PUBLIC HEARING
July 23, 2020
(Continued from July 14, 2020)

Subject: ZAB Appeal: 1533 Beverly Place, Administrative Use Permit #ZP2018-0153

Conduct a public hearing and, upon conclusion, adopt a Resolution affirming the decision of the Zoning Adjustments Board to approve Administrative Use Permit #ZP2018-0153 to enlarge an existing 1,212 square-foot, one-story single-family dwelling with a non-conforming front setback on a 4,200 square-foot lot by constructing a 1,035 square-foot addition, including a new second story that would increase the average building height from 16 feet 3½ inches to 23 feet 7½ inches, and adding a fifth bedroom, and dismiss the appeal.

Photo 1: Story Poles with Design Revision Indicated, As Seen from the Kitchen Table of 1710 Sonoma Avenue. Photo by Amy Di Costanzo.

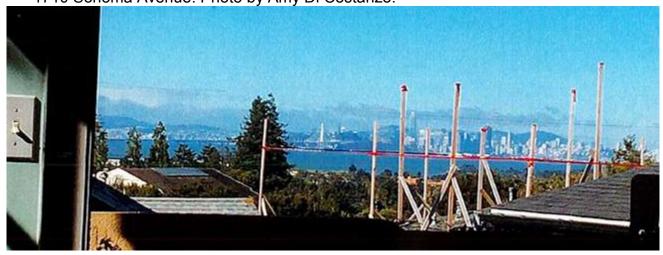
The appellant submitted photos of the view from their kitchen toward San Francisco in their appeal letter. Photo 1 below was taken from a seated position at the table at the back of the kitchen, with the doors to the deck open. The original story poles are in the photo, and the height of the proposed building after the plans were revised is indicated by the red horizontal line.

Staff Response: The BMC defines a view corridor as a "significant view of the Berkeley Hills, San Francisco Bay, Mt. Tamalpais, or a significant landmark such as the Campanile, Golden Gate Bridge, and Alcatraz Island or any other significant vista that substantially enhances the value and enjoyment of real property." The photos submitted by the appellant show the story poles at the height of the original design for the addition, with a string at a lower height to reflect the revisions to the project. The string between the story poles indicates how the applicants lowered the proposed height and replaced the sloped roof with a flat roof. With the revised addition, the Bay Bridge and San Francisco Skyline would still be visible from the kitchen of 1710 Sonoma Avenue. Although the view of the water below the Bay Bridge and San Francisco Skyline would
